COUNCIL ASSESSMENT REPORT

Panel Reference	PPSSNH-515
DA Number	eDA0223/24
LGA	Ku-ring-gai
Proposed Development	Demolition of existing structures, construction of a mixed-use development
Street Address	7-9 Merriwa Street, Gordon
Applicant/Owner	Applicant: Meccone Owner: Wei Dong Chen
Date of DA lodgement	28/06/2024
Total number of Submissions	20 total submissions
Total Number of Unique Objections	18 unique objections
Recommendation	Refusal
Regional Development Criteria - Schedule 6 of the SEPP (Planning Systems) 2021	General development over \$30,000,0000.00
List of all relevant s4.15(1)(a) matters	<ul style="list-style-type: none"> • SEPP (Planning Systems) 2021 (PS SEPP) • SEPP (Housing) 2021 (Housing SEPP) • SEPP (Biodiversity and Conservation) 2021 (BC SEPP) • SEPP (Transport and Infrastructure) 2021 • SEPP (Resilience and Hazards) 2021 • SEPP (Sustainable Buildings) 2022 • Ku-ring-gai Local Environmental Plan 2015 (KLEP 2015) • Ku-ring-gai Development Control Plan (KDCP) • Ku-ring-gai Contributions Plan 2023

To determine Development Application No. eDA0223/24 for the demolition of existing structures, construction of a mixed-use development (shop-top housing) comprising 27 re

Figure 3: Deep soil areas calculated above. Areas in yellow are excluded from deep soil calculations due to retaining walls, paths wider than 1.2m or areas less than 2m in width.

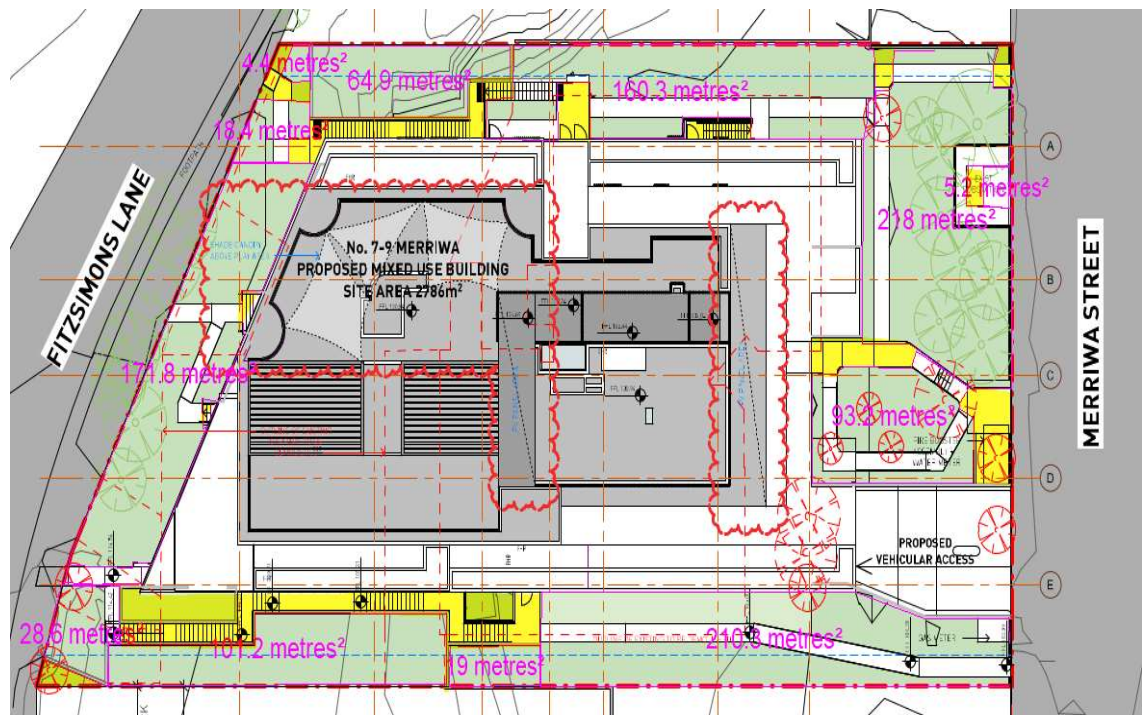
<p>Actual deep soil with minimum 2 metres dimensions = approximately 1095.4m² (39.3%) (a 298m² shortfall)</p> <p><i>The deep soil is calculated incorrectly on Deep Soil Plan DA501 G of 692m² (24.8%) as Part 8 definition used utilising 6 metres minimum dimension as requested in Council (Landscape) initial referral. However, reassessment of the definition within Part 8 'Introduction', states that if any dwelling provided to ground floor then the building is considered Residential Flat Building and assessed under Part 7. If commercial not located to the entire ground floor then it is not considered a mixed use.</i></p> <p><i>If the retaining walls to the north-western set of steps are deleted, allowing path/steps to be included within the calculations, the approximate deep soil area could be increased to 40.6% (1133.2m²). A 259.8m² shortfall would remain and would require amendments to design to increase deep soil.</i></p>

Issue: Deep Soil

The proposal fails to comply with the 50% deep soil requirement of Control 1, Part 7A.6 of the DCP. The actual deep soil area proposed with minimum 2 metres dimensions is approximately 1095.4m² (39.3%). If the retaining walls to the north-western set of steps are deleted, allowing path/steps to be included within the calculations, the approximate deep soil area could be increased to 40.6% (1133.2m²). Suspended/piered steps over existing ground levels would provide additional deep soil for tree roots. A 259.8m² shortfall would still remain and would require considerable amendments to the design to increase the total deep soil.

Figure 4: Section of OSD overflow pipe to be lowered (in yellow)

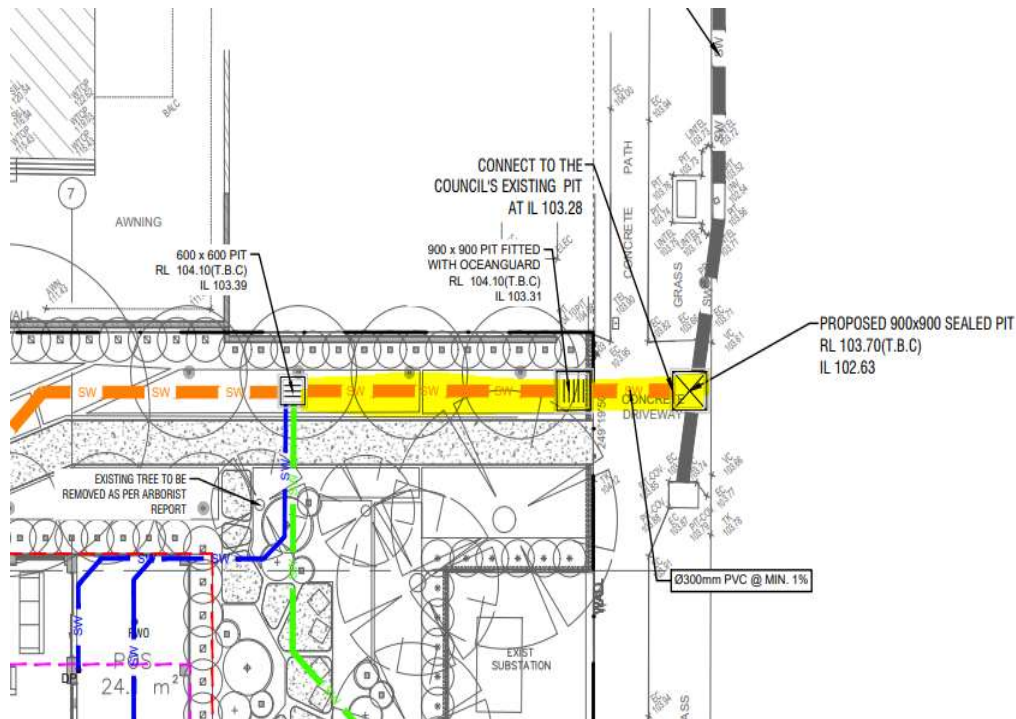
The highlighted section of the on-site detention (OSD) 300 millimetres overflow pipe along the eastern boundary, is proposed to be lowered and thrust bored to protect tree roots. The plans also depict a notation regarding the thrust boring method and confirm the levels necessary for the overflow pipe to achieve gravity discharge to the new junction sealed pit. This is acceptable.

Figure 5: Extract from applicant's Clause 4.6 variation request illustrating height blanket

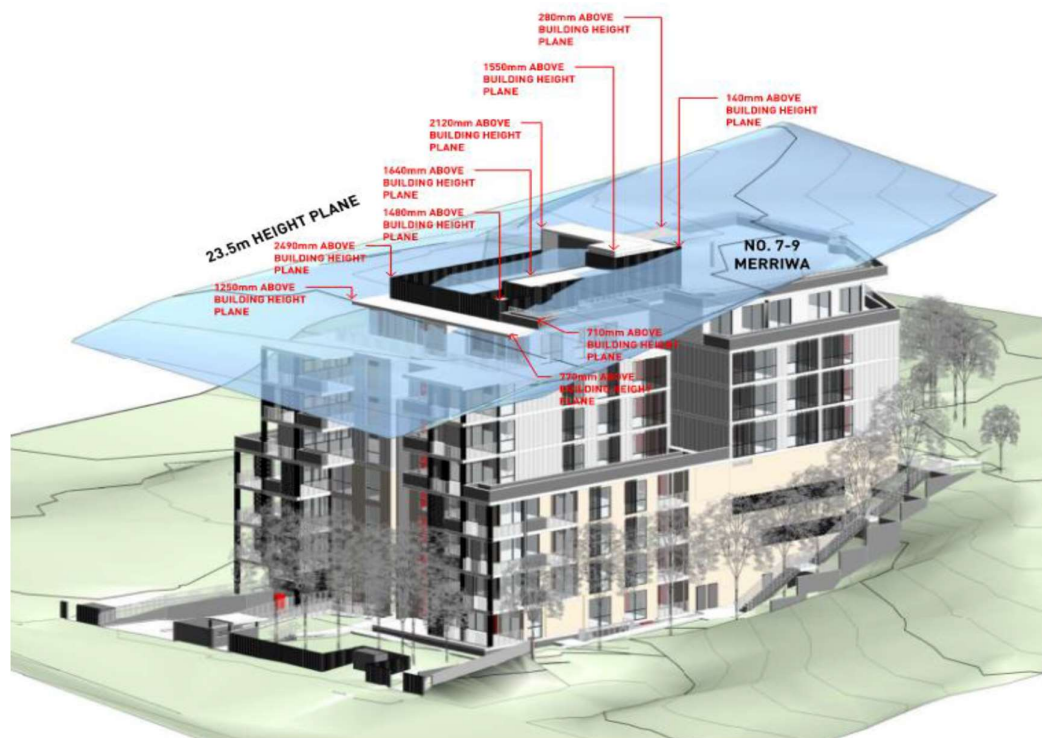
The above justification is a summary of the KLEP/KDCP standards and controls, and an explanation of which parts of the proposed development do not comply with the height of buildings standard. No environmental planning grounds are put forward in this paragraph. The proposed development fails to respond to the existing ground levels appropriately by failing to step down the site. This results in a continuous wall plate from the high side on Fitzsimmons Lane to the lower side on Merriwa Street, where the building presents as 8 storeys. The proposed breach will be highly perceptible from the properties located on the southern side of Merriwa Street, which are Zoned R2, R3 and R4. The proposal fails to adequately consider the relationship between the subject and lower density

It is agreed that the ground levels upon the subject site have been substantially excavated for the purposes of the existing commercial office building that currently occupies the site. However, this fact is not an environmental planning ground in and of itself. The location of communal open space (COS) and considerations pertaining to its location, serviceability etc, are not environmental planning grounds. The applicant has failed to demonstrate why a compliant 7 storey development and/or providing car parking at a basement level would not achieve a high quality rooftop COS. Therefore, there is no relationship between the non-compliant building height and the rooftop COS being at Level 8 instead of Level 7.

The description of which parts of the building that breach the building height development standard are not an environmental planning ground. Whilst site constraints are environmental planning
